Docket Number:	17-IEPR-01
Project Title:	General/Scope
TN #:	221729
Document Title:	California Hydrogen Business Council (CHBC) Comments Comments of the CHBC on the draft 2017 IEPR
Description:	N/A
Filer:	System
Organization:	California Hydrogen Business Council (CHBC)
Submitter Role:	Public
Submission Date:	11/13/2017 3:28:56 PM
Docketed Date:	11/13/2017

Comments of the CHBC on the draft 2017 IEPR

California Hydrogen Business Council Comments on 2017 Draft IEPR Report

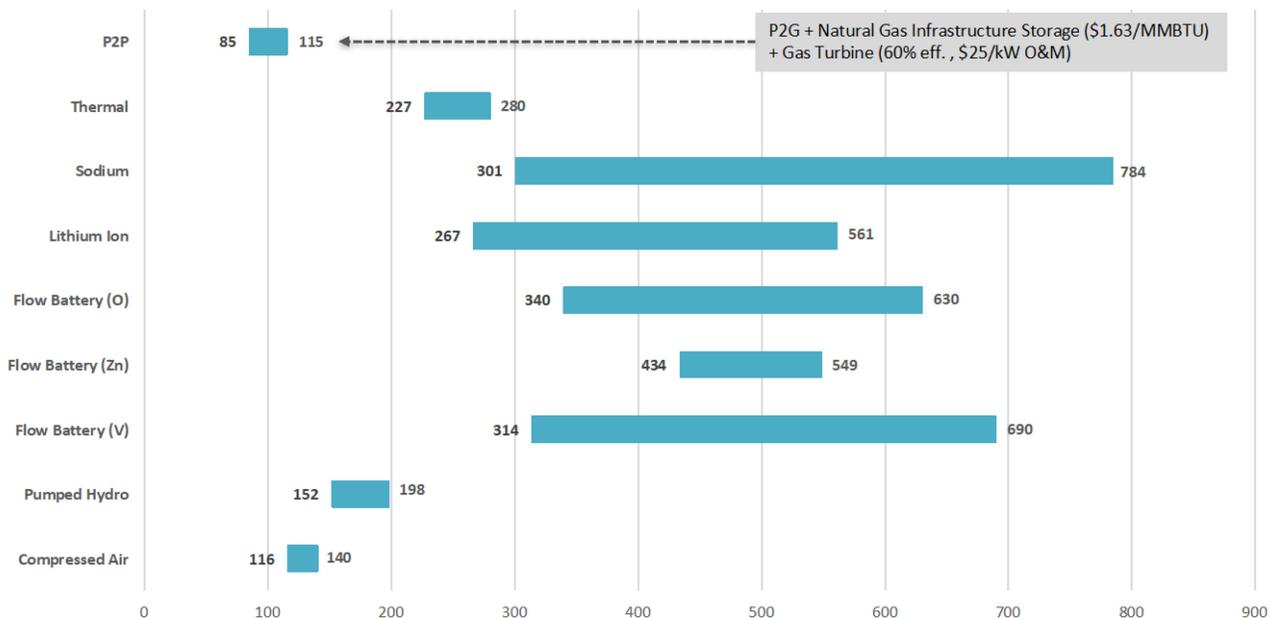
- Recently a study conducted by McKinsey & Company found that converting renewable power into hydrogen via electrolysis followed by salt cavern hydrogen storage and use of combined cycle power

plant conversion back to electricity (i.e. P2G2P) was cheaper than pumped hydro storage. The findings showed that with a round trip efficiency of 40% and capital costs of \$1000/kW, this approach has a lower levelized cost of electricity than pumped hydro storage, the current lowest cost energy storage solution.³³
